Access Compliance Report

Public Rights-of-Way

(Curb Ramps)

Intersection ID: 11262	Main Street: EASTWAY_DR	Cross Street: FRONTENAC_AV	Location: SE
ADA ID: 4485ED5B1E59	Ramp Type: Perp	Initial Pass/Fail: Fail	Overall Compliance: No
Severity Score: 1.25			
Codes/Mitigation Info/Possible Solution		Field Measurements/Component Compliance

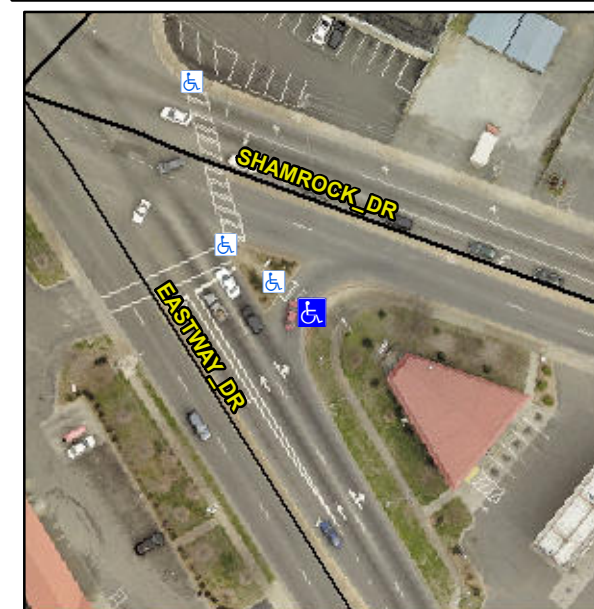
Not Found, R304.5.3

Compliance	Description	Data	Compliance	Description	Data
N/A	Ramp Length (in)	93.5	Yes	Ramp Slope (%)	5.2
Yes	Ramp Width (in)	48.0	No	Ramp XSlope (%)	3.8
N/A	Flare Type LT	N/A	N/A	Flare Type RT	N/A
N/A	Flare Slope LT (%)	N/A	N/A	Flare Slope RT (%)	N/A
N/A	Flare Traversable LT?	N/A	N/A	Flare Traversable RT?	N/A
N/A	Landing Length (in)	N/A	N/A	DWS Provided?	N/A
N/A	Landing Width (in)	N/A	N/A	DWS Contrast?	N/A
N/A	Landing Slope (%)	N/A	N/A	DWS Length (in)	N/A
N/A	Landing X Slope (%)	N/A	N/A	DWS Full Width?	N/A
N/A	Landing Curb? (Y/N)	N/A	N/A	DWS Offset (in)	N/A
N/A	Shared Landing?	N/A			
N/A	Gutter Ponding?	N/A	N/A	Gutter Slope (%)	N/A
N/A	Gutter Lip Ht (in)	N/A	N/A	Gutter X Slope (%)	N/A
N/A	Painted X Walk1?	Yes	N/A	Painted X Walk2?	N/A
	X Walk 1 Direction	To NW		X Walk 2 Direction	N/A
N/A	X Walk 1 Width (in)	110.0	N/A	X Walk 2 Width (in)	N/A
	X Walk 1 Slope (%)	5.1		X Walk 2 Slope (%)	N/A
	X Walk 1 X Slope (%)	3.4		X Walk 2 X Slope (%)	N/A

Remove & Replace Entire Ramp.
